## BUREAU OF LAND MANAGEMENT

IN REPLY REFER TO:  
3590  
UTU-0122693  
(UT-923)

Re: Reclamation Issues for Federal Gilsonite Lease UTU-0122693

**Figure 1 Cowboy Bandana Shaft 04/07/2005**

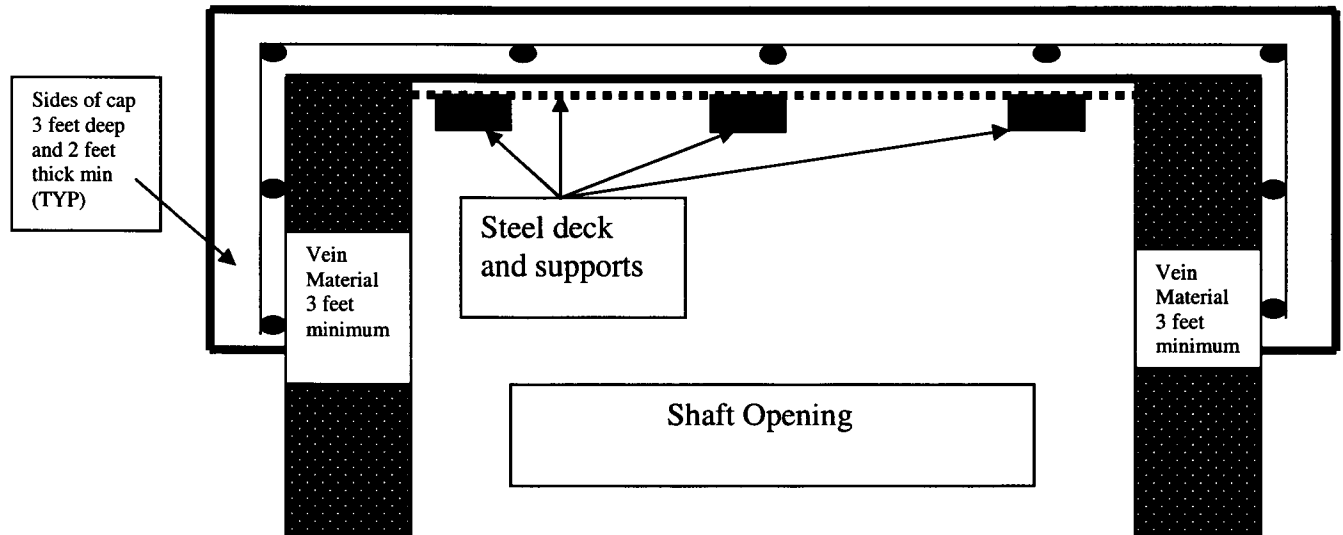
The Bureau of Land Management (BLM) inspected the Cowboy-Bandana mine site (fig 1.) on April 7, 2005 and has some concerns with the condition of the shaft. BLM was told by representatives of Ziegler that the shaft has been filled with broken concrete material. BLM notes that signs have been placed on the site to warn people of the open shaft. BLM requires the shaft be closed immediately to remove any liabilities that would be associated with the shaft.

BLM recommends that the shafts be filled with non combustible material. If there is insufficient material available, then the shafts should be capped. The caps must be sealed in non-weathered ground material. On the sides, the caps must overlap the vein at least 2 feet or the width of the vein which ever is greater. On the strike of the vein the cap must overlap the shaft opening at least 3 feet. The caps must be constructed of reinforced concrete. The cap must extend down into the vein at least 3 feet. This will be at the cap end. Steel supports are recommended for supporting the forming of the caps. The top of the caps must be at least 2 feet below ground surface (See Drawing 1). The caps must be covered with a water proofing material prior to placing soil over the top of the cap. All material in the shafts should be removed such as vent pipes and upper ladders etc. The areas around the caps should be fenced to ensure that people and animals are kept away from the shaft site.

BLM will require inspecting the site and approve the forming and construction prior to pouring of the cap.

**Figure 2 East Escapeway Cowboy Bandana mine**

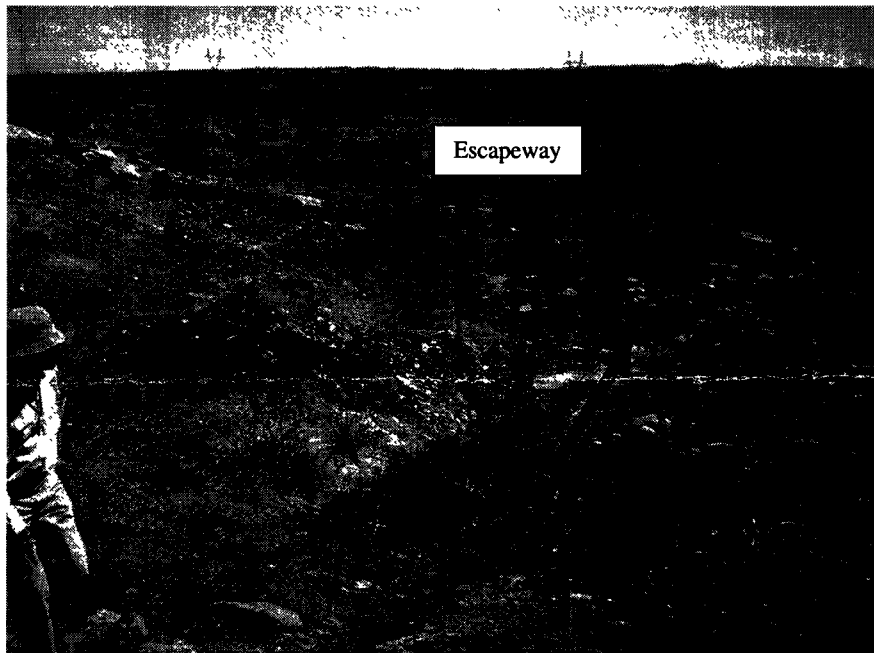
In addition, the cap on the east escapeway (fig. 2) has been removed because the water going down the drainage was undercutting the cap. BLM recommends that the small drainage be moved to the approximate location shown by the large heavy arrow in the picture below.

BLM feels that this would be the best solution to this problem. The gilsonite material should be placed in the escapeway and this area should be left higher than the other areas. There should be a berm of large competent material should be to maintain the drainage away from the escapeway.
